1959 - 1960 Corvette: Service Bulletin: Front and Rear Door Glass Loose in Run Channels

Subject: Front and Rear Door Glass Loose in Run Channels
Model and Year: 1959 - 1960 Passenger Cars
Source: Chevrolet Technical Service Bulletin
Bulletin No: DR #651
Section: I
Date: April 7, 1960

FIGURE #1

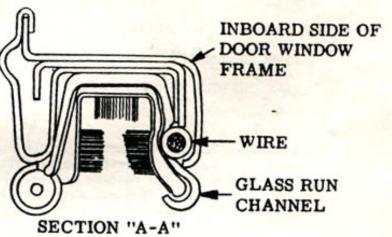
The condition of "in and out" looseness may be corrected by installing black insulated wire or similar material between the glass run channel and the inboard side of door window frame as shown in Section "A-A", figure #1. Wire should be approximately 15" long. Insert wire from belt line to top of window frame. Trim off excess wire as required.

The degree of "in and out" movement of the door window will determine the gauge of wire necessary to correct this discrepancy; however, a #14 gauge wire will normally correct the condition. On doors where the "in and out" movement of the window is very small, #20 gauge wire may be adequate.

If glass is still loose, a second piece of wire may be inserted between the channel and outboard side of window frame.

On front doors, the repair may be performed along the door lock pillar section only. However, on rear doors, the repair may be performed along either lock pillar or hinge pillar sections, or both, depending upon severity of condition.
